ENVIRONMENTAL WATER CAUCUS COMMENT LETTER
BAY DELTA CONSERVATION PLAN AND EIR/EIS
JUNE 11, 2014

Subject: Comments on the Draft BDCP and Draft BDCP EIR/EIS

**Comments of the Environmental Water Caucus
Bay Delta Conservation Plan and Its Environmental Impact Report/Statement**

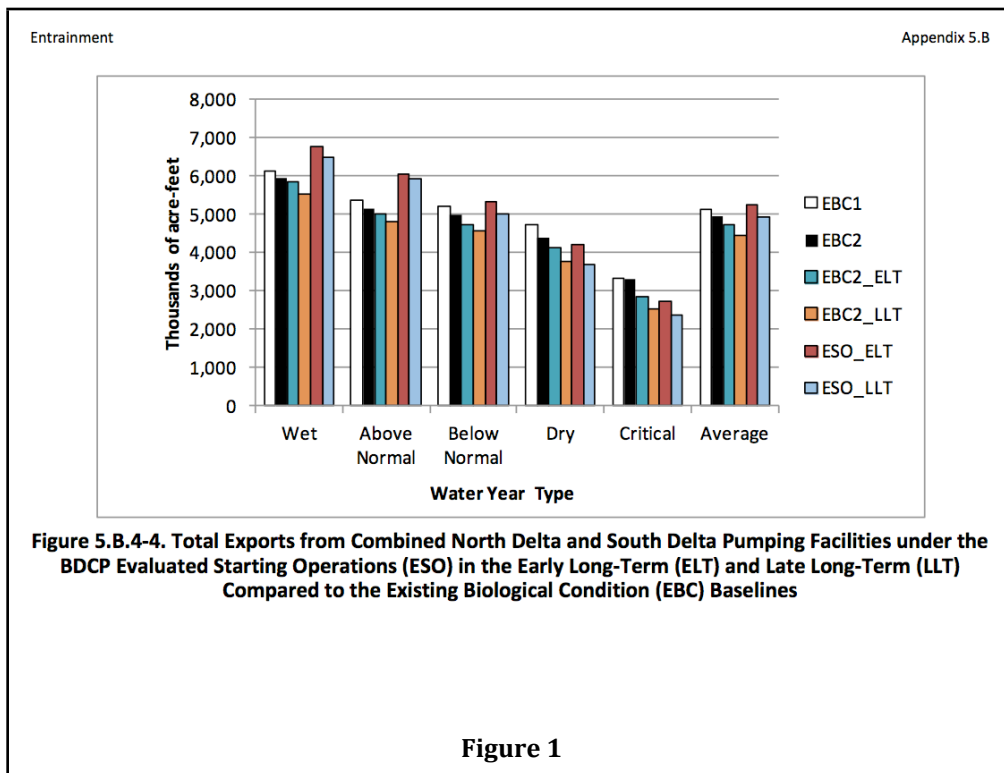
Figure 5.B.4-1 also shows that the North Delta Intakes will be used only minimally during below normal, dry, and critically dry water years. In these years, the South Delta intakes will continue to operate as they have in the past during these years. In the 82-year record on which CalSIM II modeling is based for BDCP purposes, just 38 years have been above normal or wet; the remaining 44 years are generally much drier (dry and critically dry years account for 30 (or 37 percent) of the remaining 44 water years). Both this figure and Figure 5.B.4-4 (here in Figure 1) show that the utility of the North Delta Intakes would decrease dramatically in drier weather patterns and climate conditions. It appears to us that the analyses in these figures rely on the existing variability of California's hydrologic record and its existing frequency of water year types. What is the risk in terms to fish entrainment and cost-effectiveness of the Twin Tunnels project if in a future of climate change the proportion of dry years increases relative to wet years?

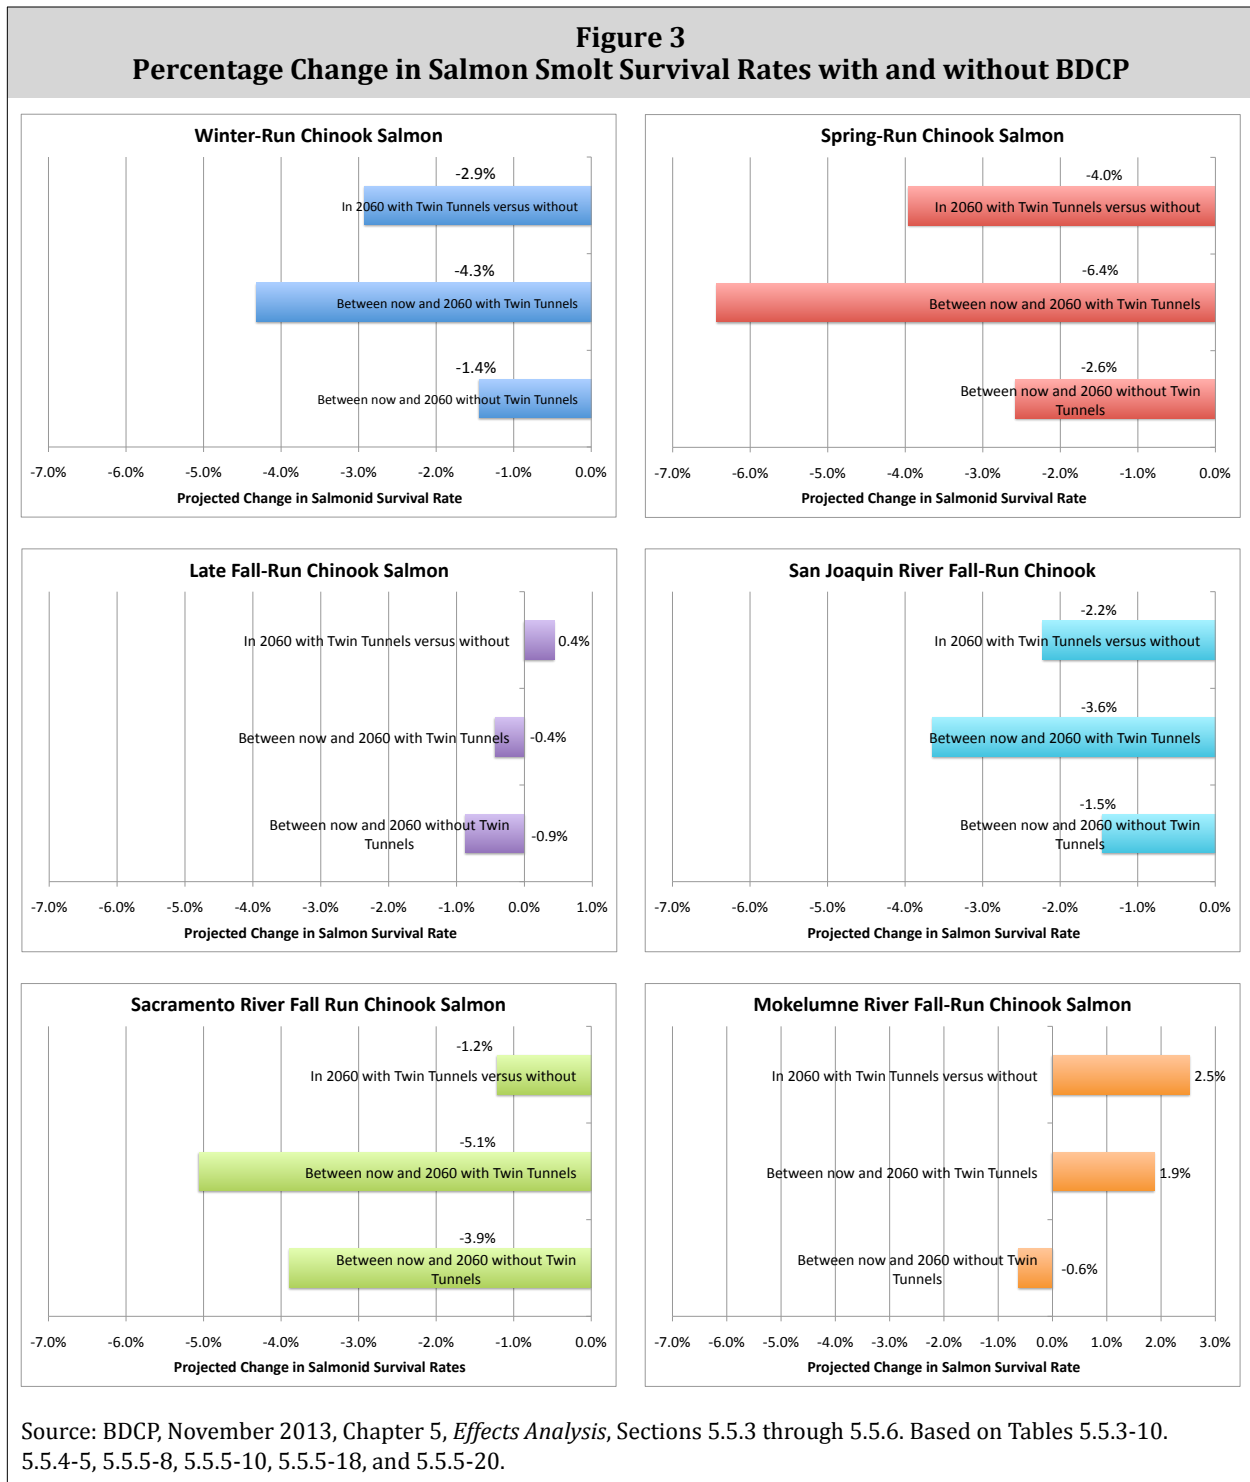
- The Bay Delta Conservation Plan modeling results reveal salmon smolt survival rates will decrease through the Delta as a result of Twin Tunnels operation in the North Delta (Figure 3).

The middle bars in each graph of Figure 3 show the comparison between present baseline conditions and 2060 with operation of a Twin Tunnels project and North Delta Intakes. For Winter-

run Chinook, smolt survival through the Delta is expected by BDCP to *decrease* 4.3 percent. For Spring-run Chinook, smolt survival through the Delta is expected by BDCP to *decrease* by 6.4 percent. For Sacramento River Fall-run Chinook, smolt survival is expected to *decrease* 5.1 percent. For San Joaquin River Fall-run Chinook, smolt survival is expected to *decrease* 3.6 percent. (No model results were available for Central Valley steelhead.) ***These are significant, appreciable reductions to listed species during critical life stages as they move through the Delta.***

**Figure 8
Residence Time of Water in Various Delta Regions**

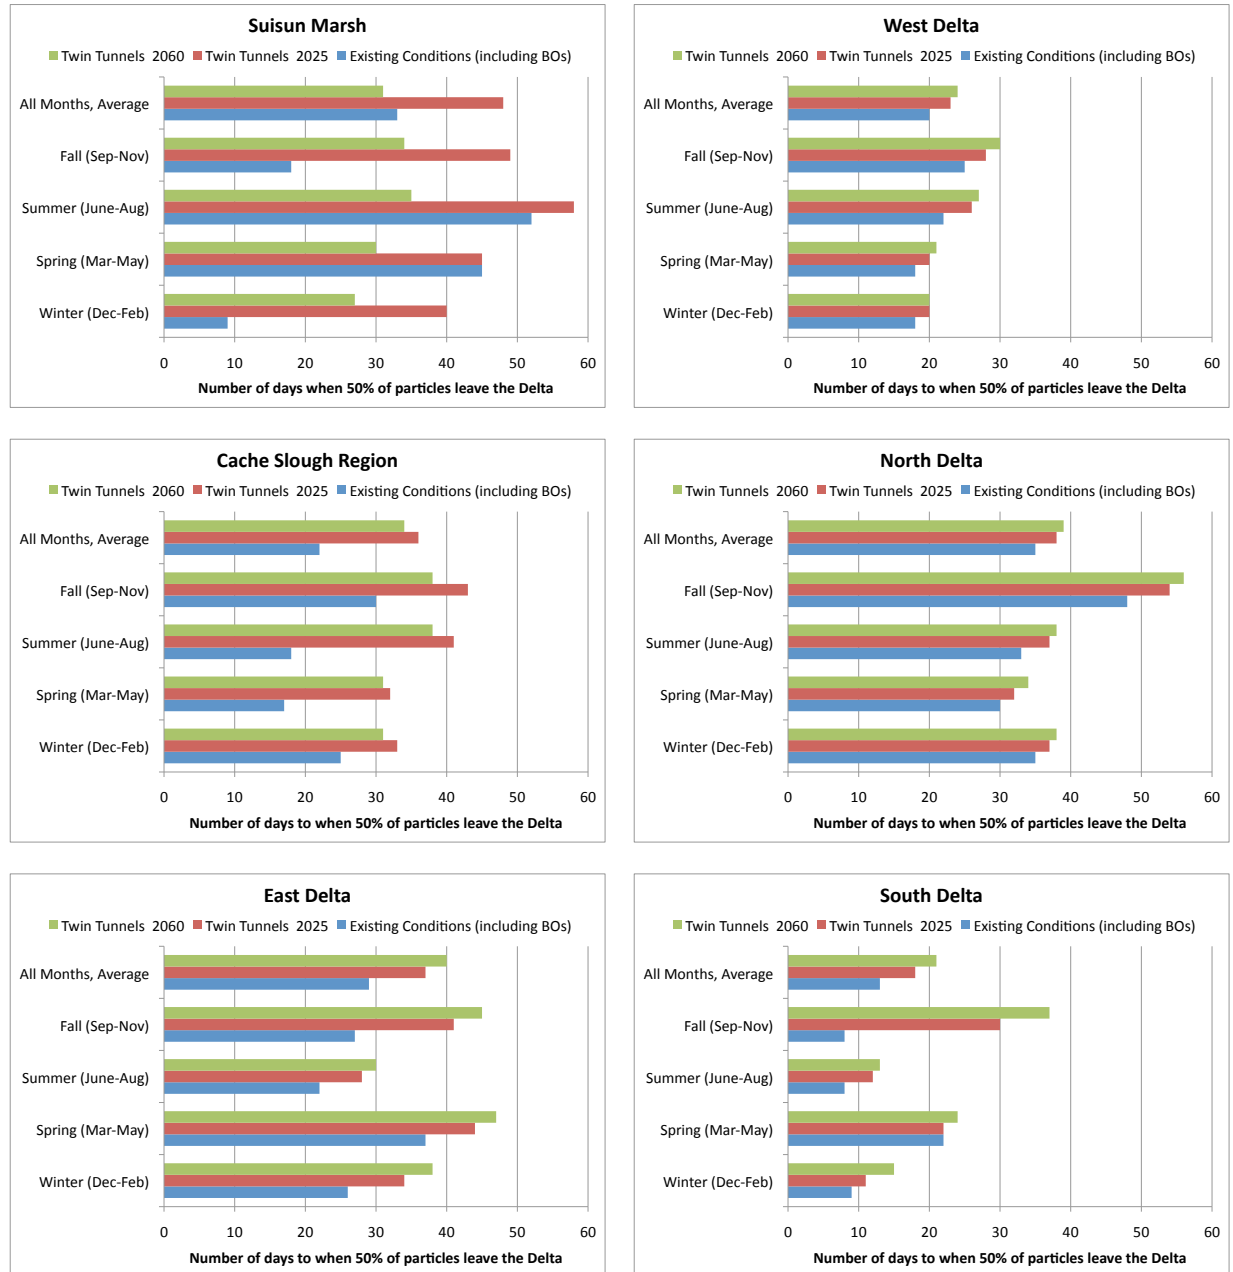
West Delta residence time is significant here as well since that area is just downstream of Cache Slough outflow and just upstream of Suisun Marsh, so it most closely approximates the residence time of water present in Delta outflow to Suisun Bay. According to BDCP modeling presented in Figure 8 above, Twin Tunnels operations will *increase* residence time in all seasons and in the annual average, and residence time will increase under Twin Tunnels operation between 2025 and 2060. West Delta residence times retain their clear seasonally-increasing trend, where they are lowest in winter, increasing through spring and summer somewhat to fall when residence times are about 25 to 33 percent higher than in winter (e.g., 30 days of residence time in the fall versus 20 days under Twin Tunnels operations by 2060).

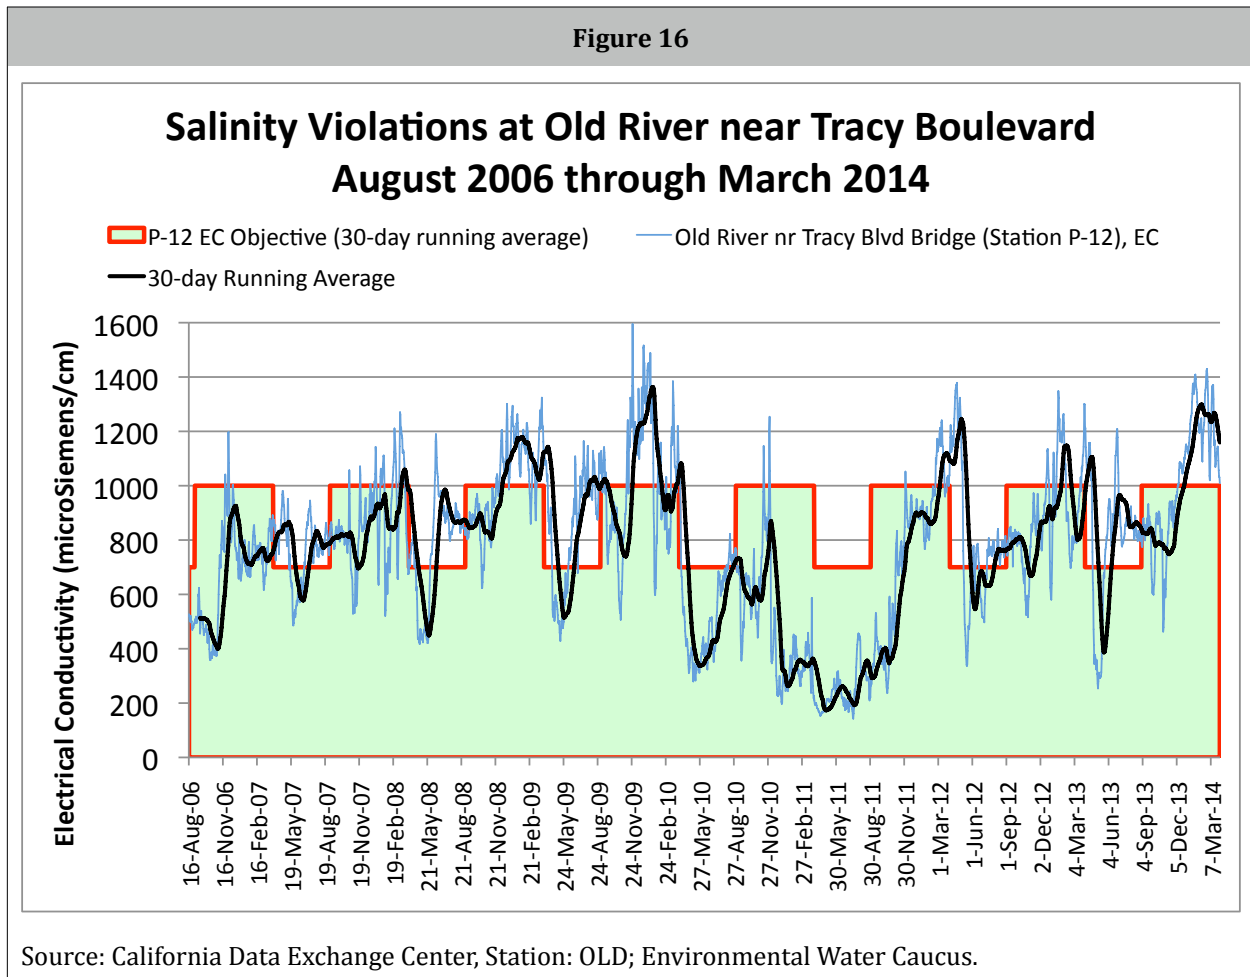
In 1992 Balance Hydrologics found that a minimum carryover storage of 900,000 AF was necessary to meet Basin Plan temperature objectives.¹⁵⁹

**Figure 17
Projected Salinity Effects by 2060
of the Twin Tunnels Project/Bay Delta Conservation Plan
Percentage of Time Salinity Exceedances and Violations Would Occur**

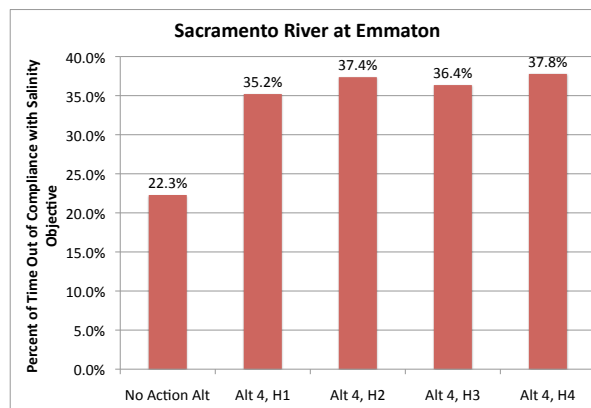
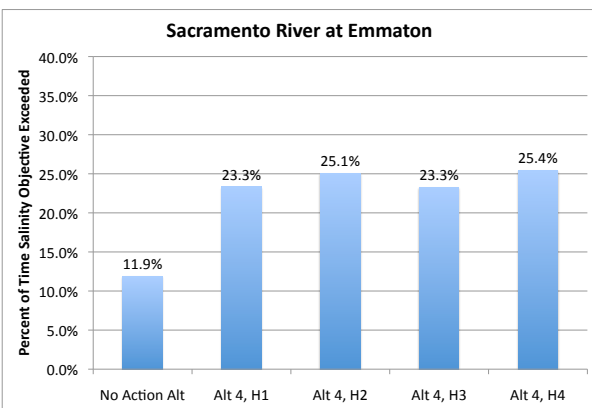
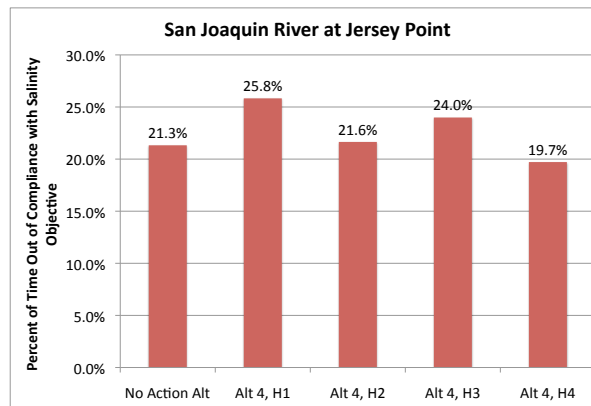
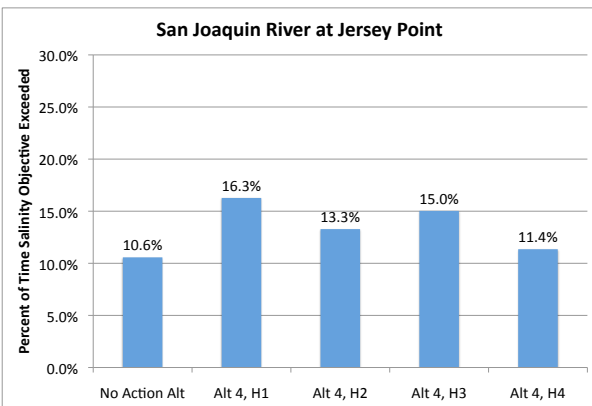
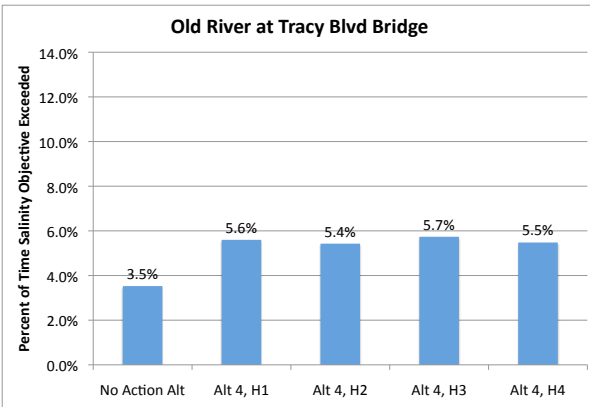
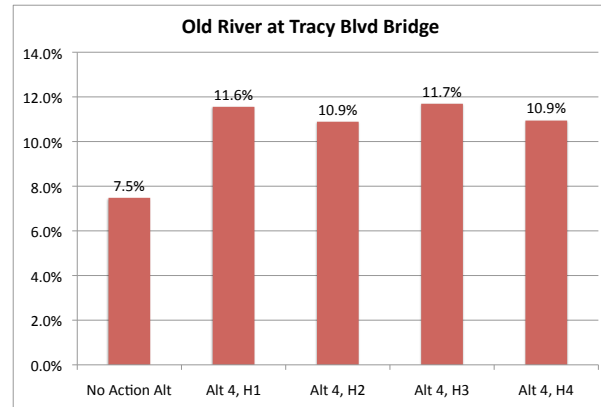
- **Sacramento River at Emmaton:** Exceedances increase over the No Action Alternative by nearly to over 100 percent of the time in the Alt 4 scenarios, while noncompliance with the objective increases by over 50 percent of the time over the No Action Alternative.

- **San Joaquin River at Jersey Point:** exceedances increase over the No Action Alt by nearly 15 to 80 percent, while non compliance with the objective increases similarly, and decreases slightly in the High Outflow Scenario (where both Spring and Fall X2 apply).

- **Old River at Tracy Blvd Bridge:** Exceedances increase by about two-thirds typically over the No Action Alternative. Noncompliance with the objective would increase by one-third to 40 percent. These percents are lower because as shown above (Table 2) the existing rate of violations is already high.

- **San Joaquin River at Prisoners Point:** The percent of time exceedances would occur increases sharply—1200 to 1900 percent increase in exceedances and a similar similar range for noncompliance. This is a fish and wildlife-related salinity objective, while the other three are agricultural beneficial use salinity objectives.

Figure 20
BDCP Water Supply
Beneficial Effects

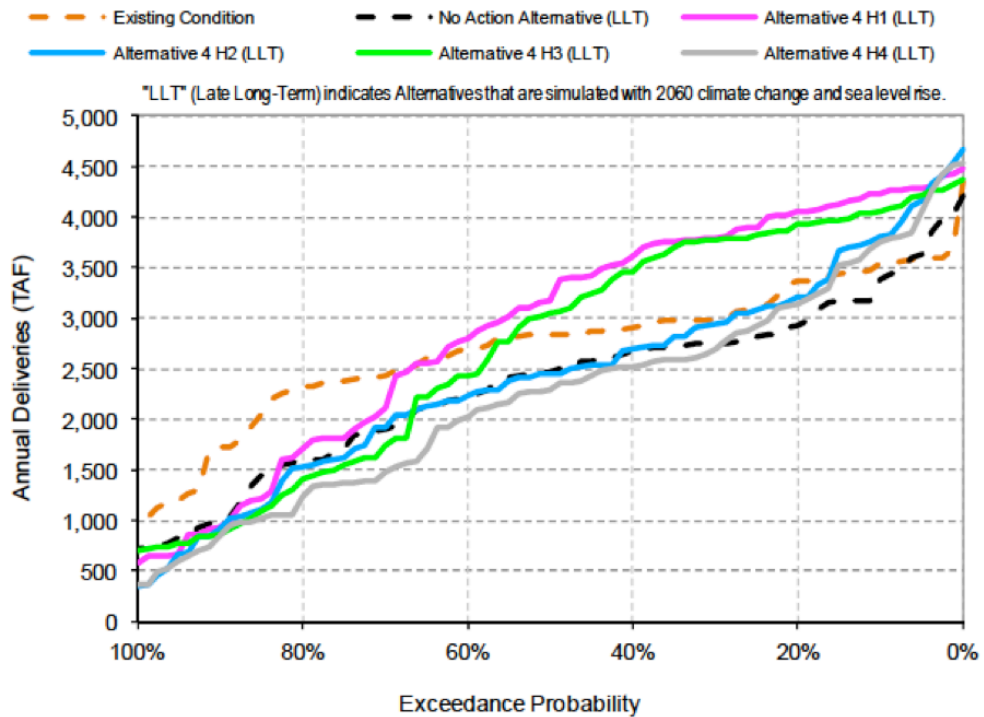
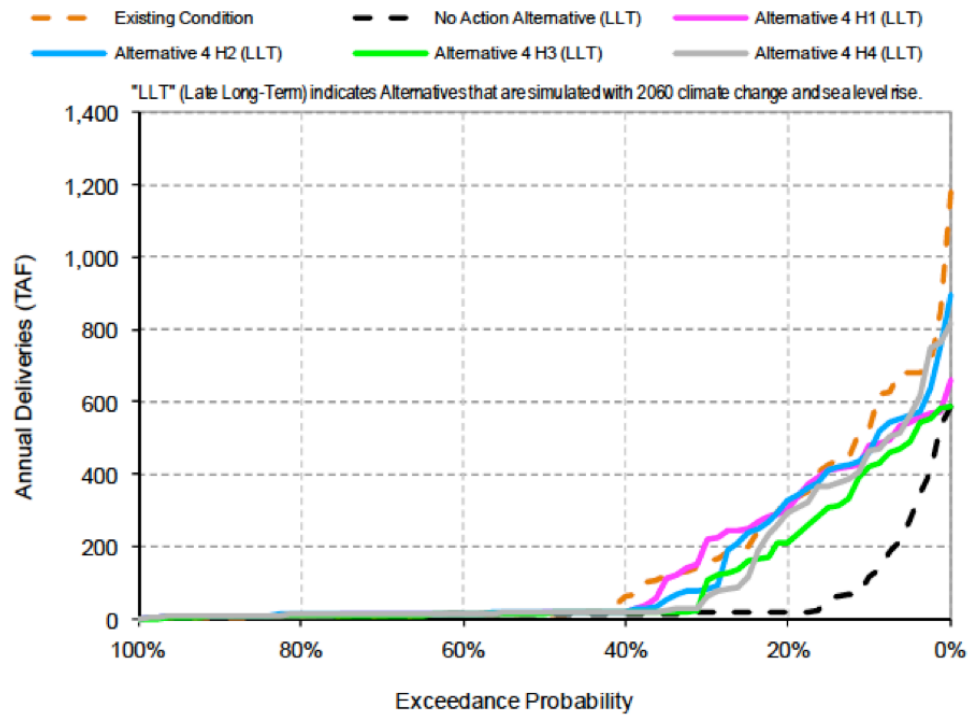
The excerpt from Figure 5-34 depicts a similar analysis for annual south of Delta SWP deliveries (including Table A contract amounts as well as potential “surplus waters” via Articles 21 and 56 of SWP contracts). This chart shows that for Alternative 4’s scenarios South of Delta deliveries perform no worse (and some better) than the No Action Alternative. Only the Alternative 4/H4 scenario benefiting both longfin smelt and Delta smelt with extra spring and fall Delta outflows provides deliveries lower than the No Action Alternative in almost 70 percent of years (including all of the driest). The other alternatives are lower than the No Action Alternative in only about 20 to 35 percent of the driest years.

The excerpt from Figure 5-36 illustrates SWP Article 21 surplus water deliveries for all BDCP Alternatives. We show the frame for each of the four Alternative 4 scenarios. It is important to note that SWP Article 21 deliveries to South of Delta contractors nearly approximates “existing conditions, and greatly exceeds the No Action Alternative. ***It is an underlying purpose of BDCP to use conveyance changes to “restore” surplus Article 21 water deliveries to South of Delta SWP contractors relative to their reduced No Action Alternative prospect.*** The No Action Alternative envisions near zero Article 21 deliveries except in about the wettest 15 to 20 percent of years in the future. The Twin Tunnels project (Alternative 4) would about double the frequency of Article 21 deliveries to State Water Project south-of-Delta water contractors.
